Luther Park Center PUD amendment - 2824 E 16th Street

ZON2007-00069

APPROVAL of a request from Luther Park Health Center, Inc. represented by Denny Garland (officer) to amend the Luther Park Center PUD for property located in the vicinity of 2824 East 16th Street to provide an additional 22 units, reduce front yard setbacks to 26' on Hull Avenue and 28' on E. 16th Street and reconfigure off-street parking subject to the following modifications: (ZON2007-00069)

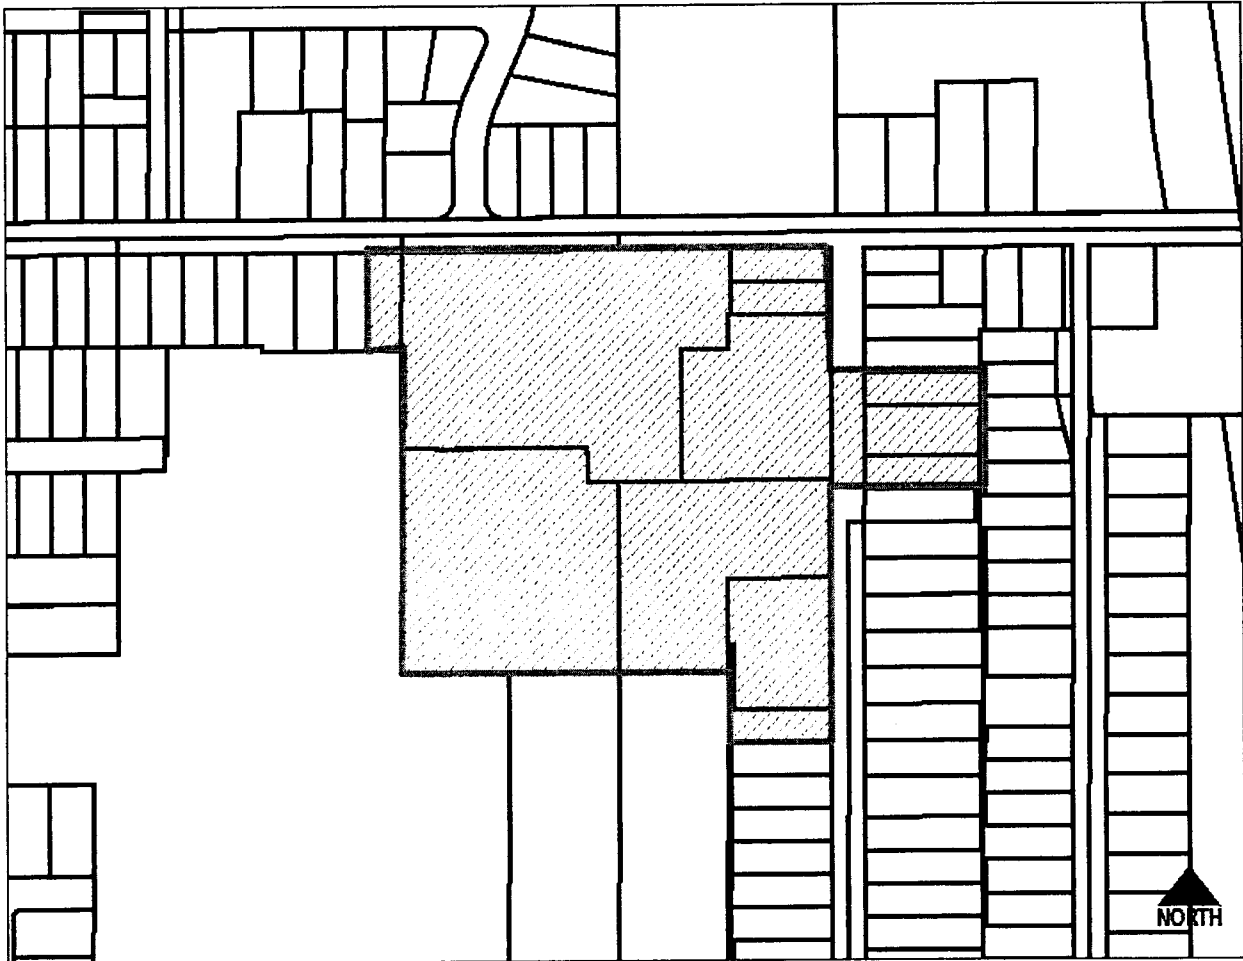
1. Revise to show the existing and proposed plantings and screening to meet landscaping requirements as applicable to "R-3" Districts for the reconfigured off-street parking area along Hull Avenue.
2. Addition of dimensions on the plan for revised minimum building setbacks and for off-street parking setback distances.
3. Provision of replacement over-story trees to mitigate those to be removed by the parking modifications.
4. Provision of architectural elevations for the single-story addition to the northwest building and labeling of materials for the dining addition on the elevations for the east building.

1. Revised to show the existing and proposed plantings and screening to meet landscaping requirements as applicable to "R-3" Districts for the reconfigured off-street parking area along Hull Avenue.
2. Addition of dimensions on the plan for revised minimum building setbacks and for off-street parking setback distances.
3. Provision of replacement over-story trees to mitigate those to be removed by the parking modifications.
4. Provision of architectural elevations for the single-story addition to the northwest building and labeling of materials for the dining addition on the elevations for the east building.

LUTHER DINING ADDITION

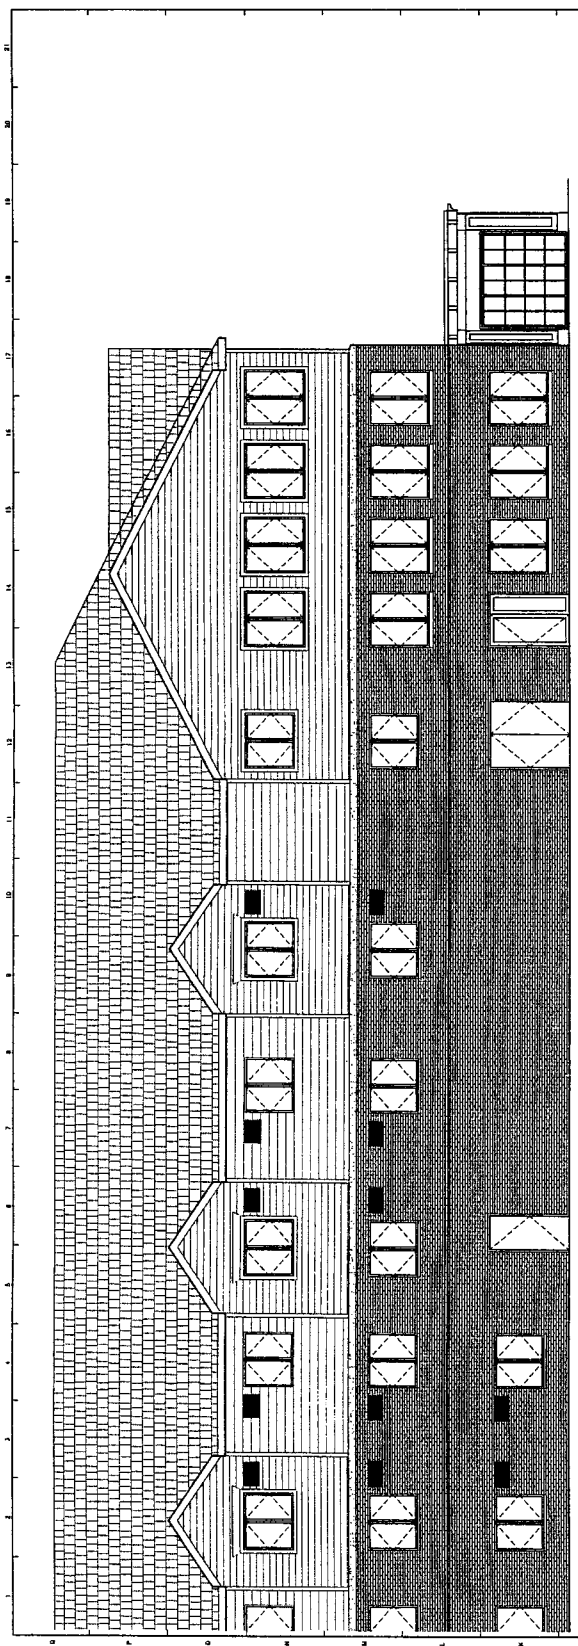
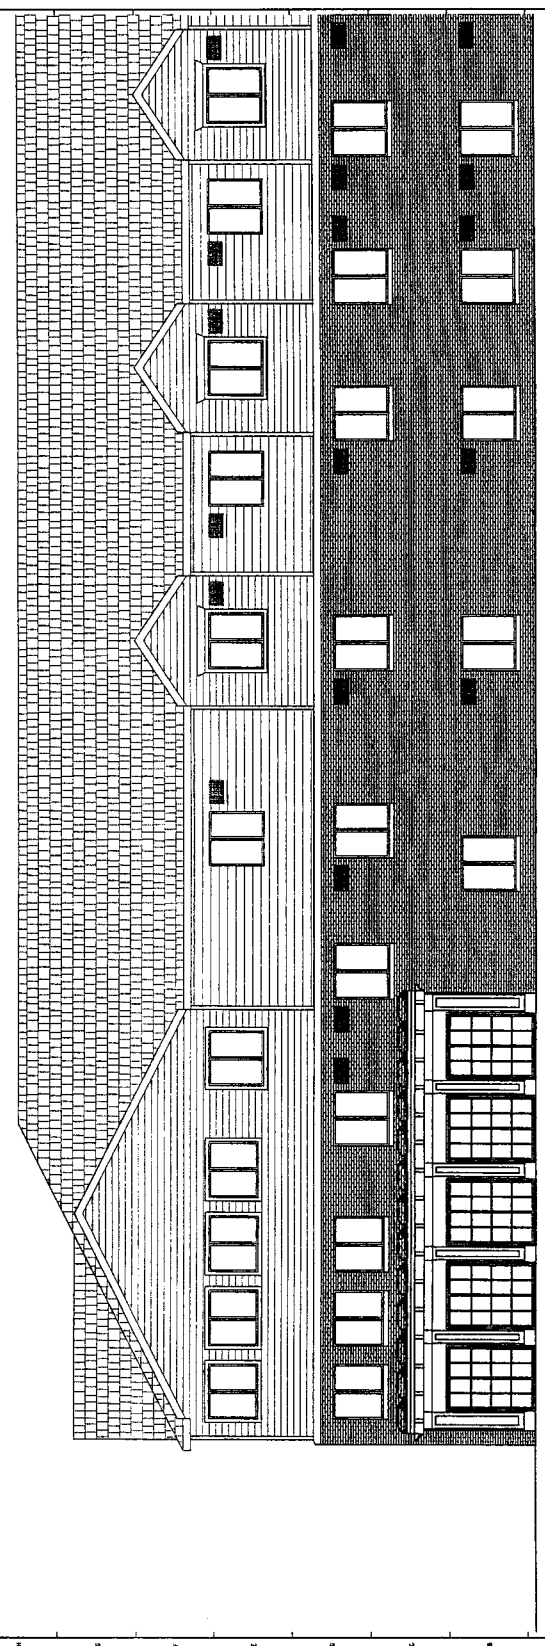
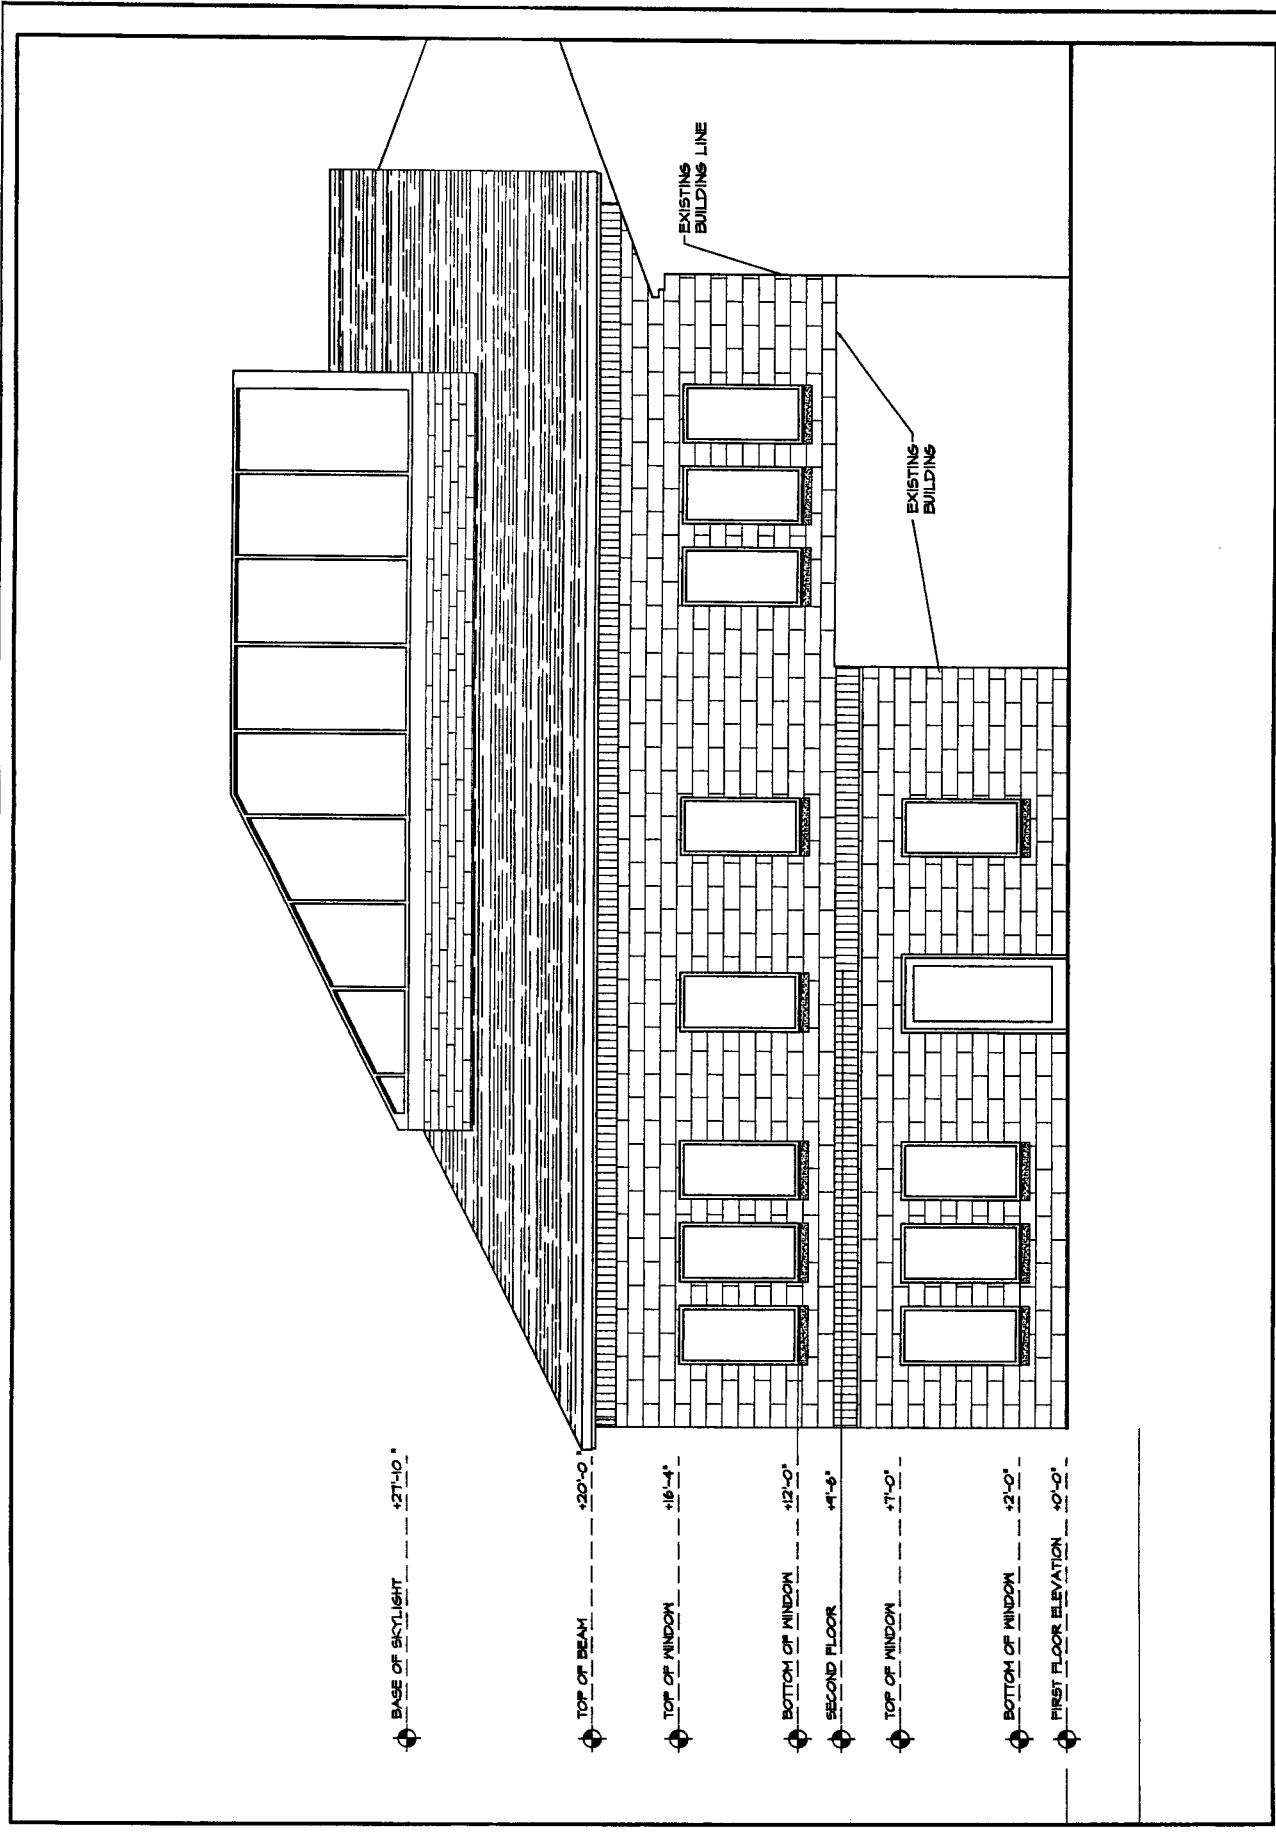
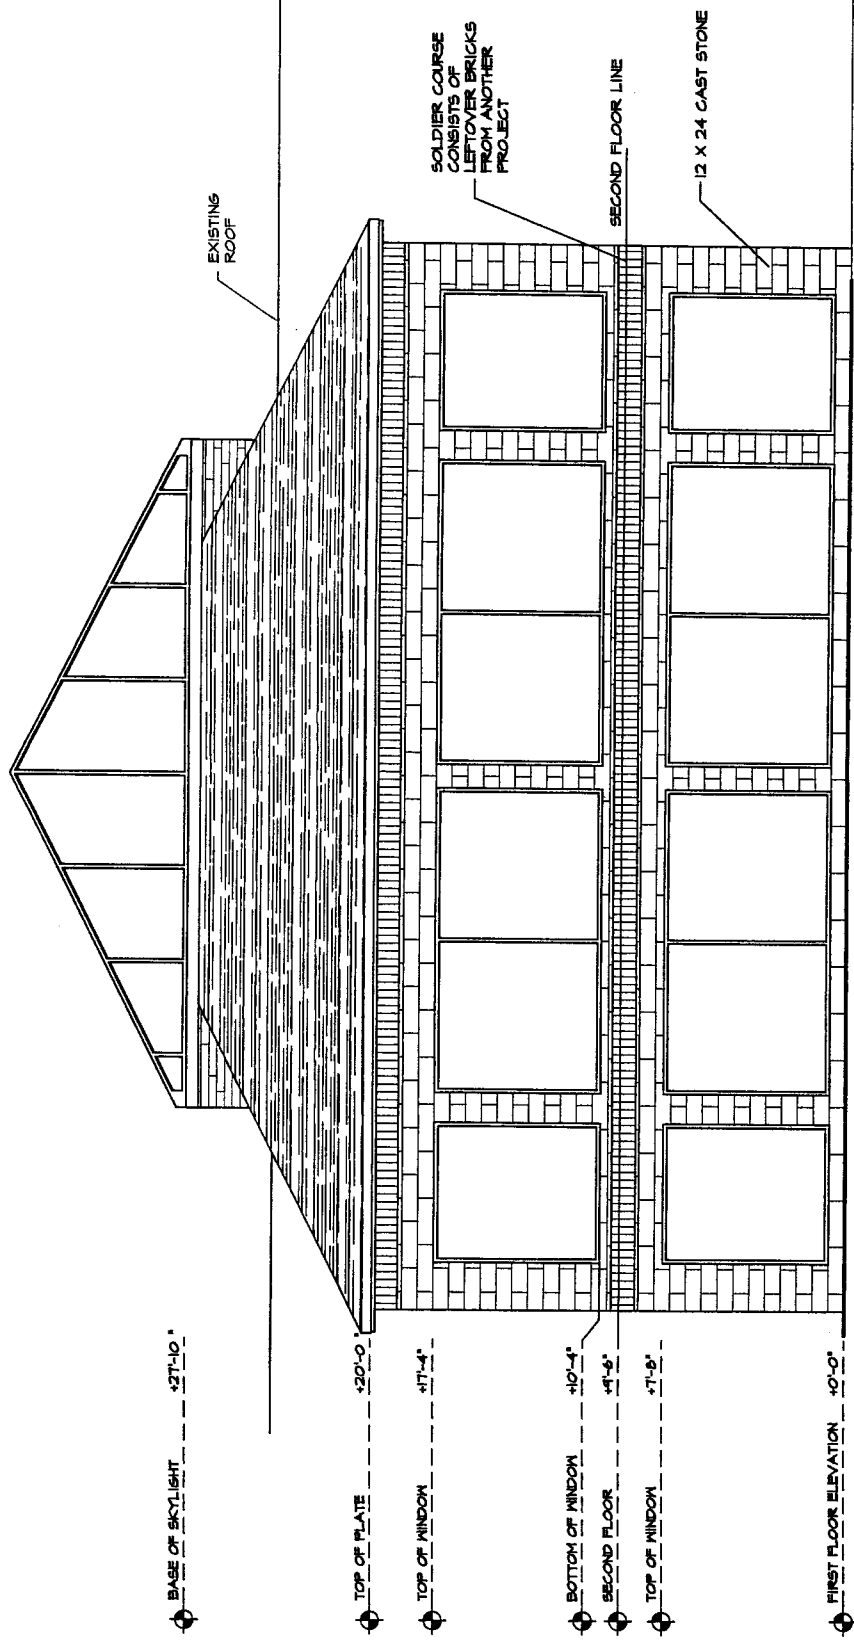
The proposed one-story dining hall addition on the southeast side of the building is flat roofed comprised primarily of muntin divided glass with painted detailed square columns and roof cornices with evenly spaced brackets. There are planters shown on the roof.
